CASE #PL2021-42

WALSER TOYOTA BLOOMINGTON, MN

Reviewed for Code Compliance
Date: 11/04/2022
By: K. Bayer
Plan # PRBD202210606

2022 NEW BUILDING FOR:
WALSER TOYOTA
4401 AMERICAN BLVD
BLOOMINGTON, MINNESOTA

MEZZ PLAN &
SKYWAY PLAN

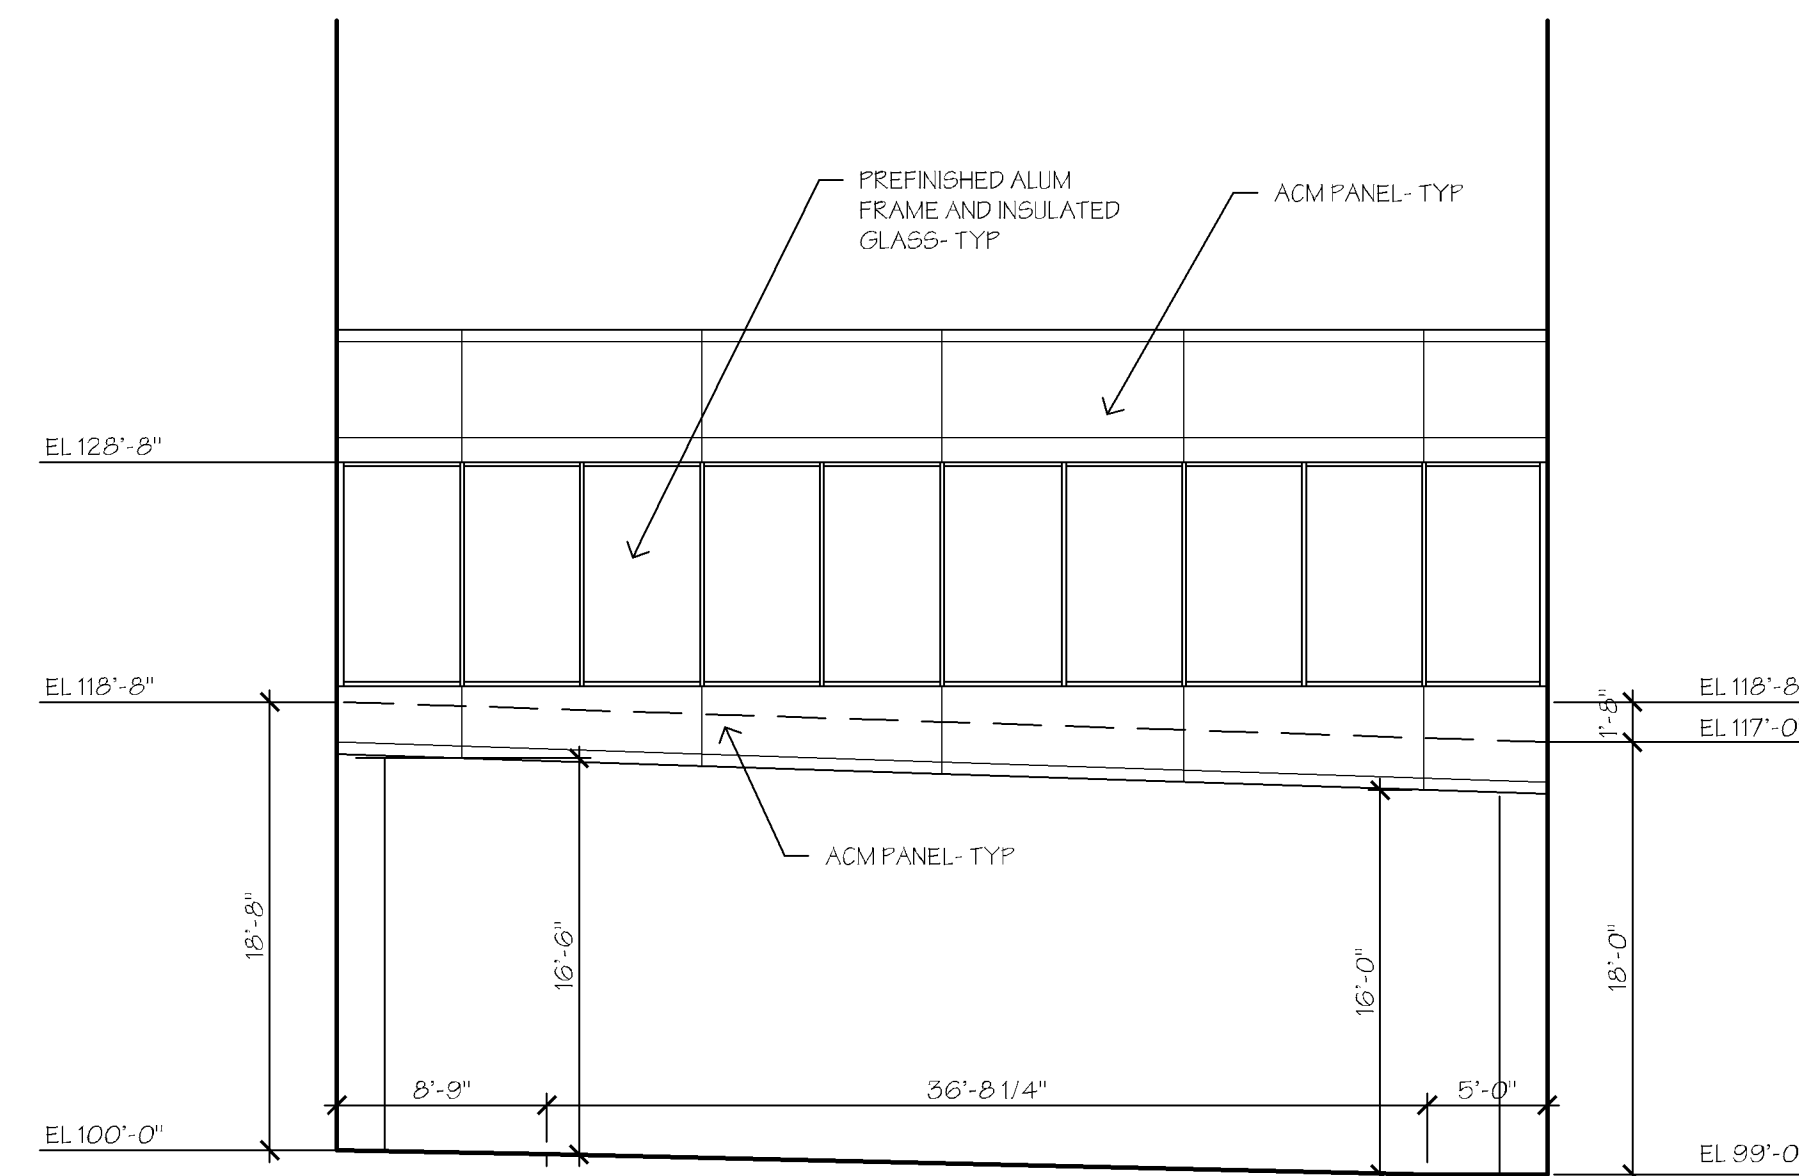
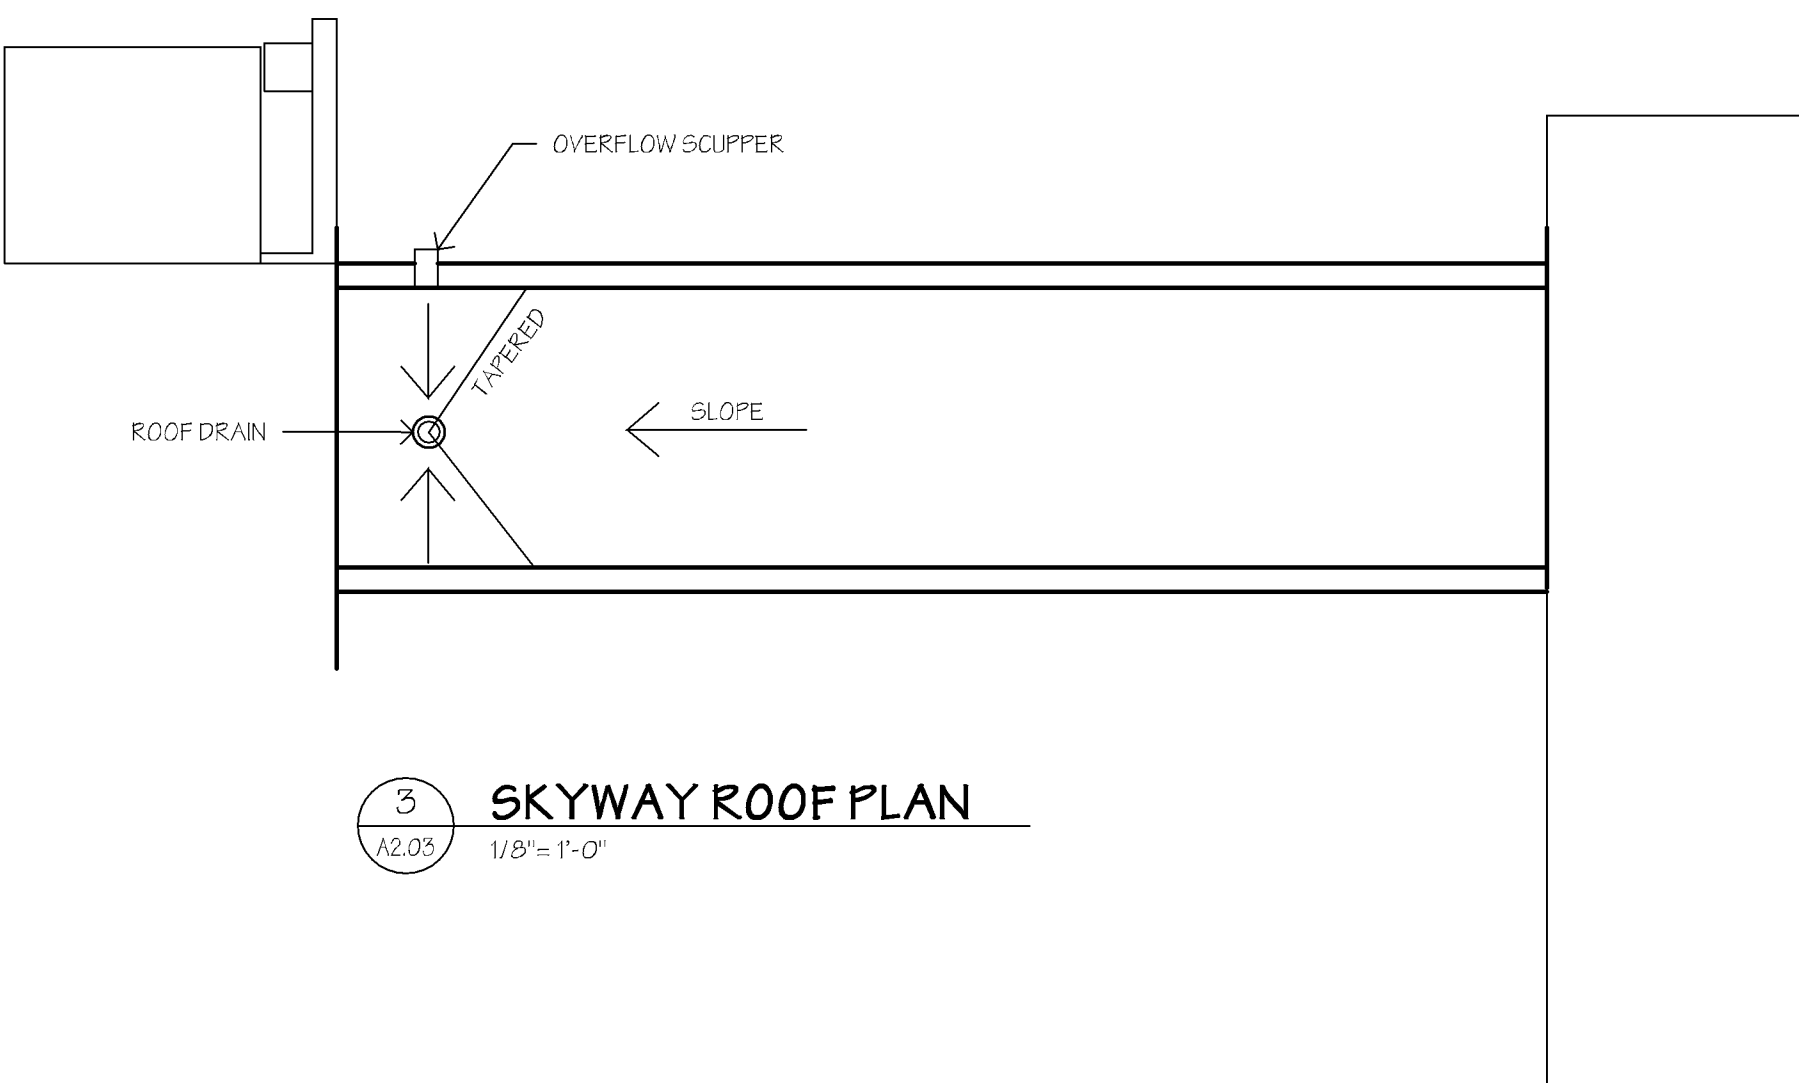
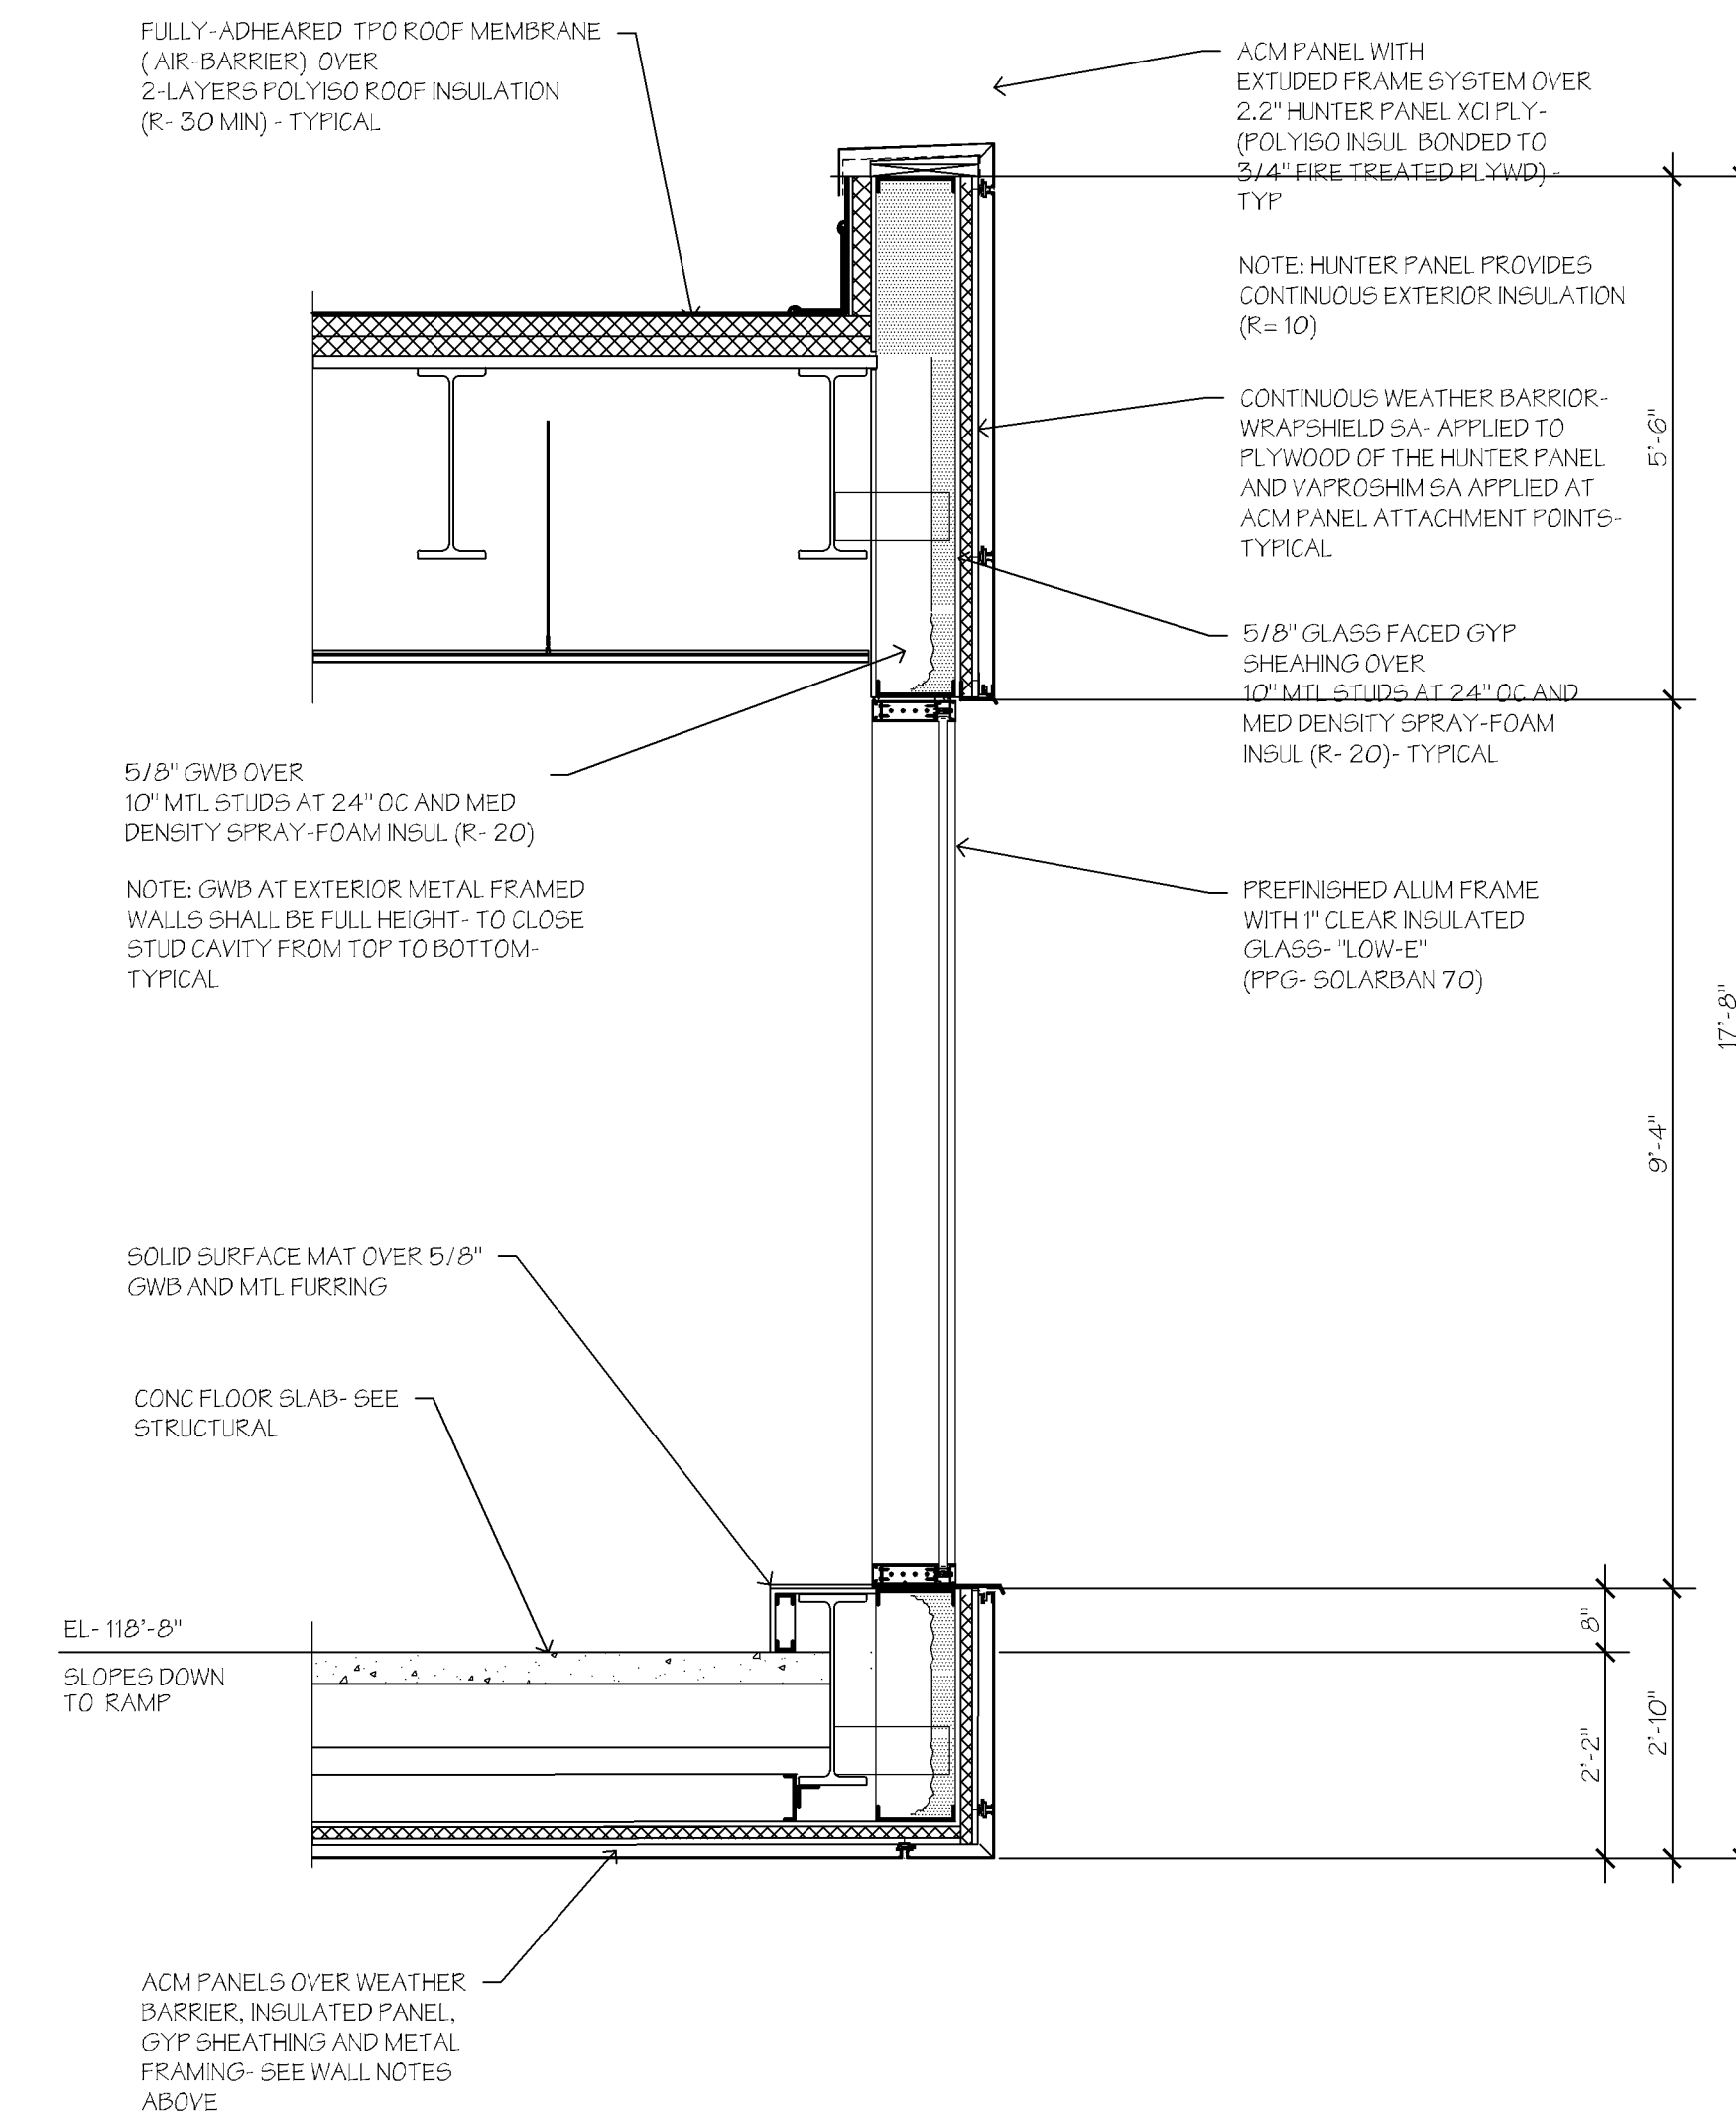
The Pedestrian Walkway shall comply with all requirements of Section 3104 of the 2020 MN Building Code.
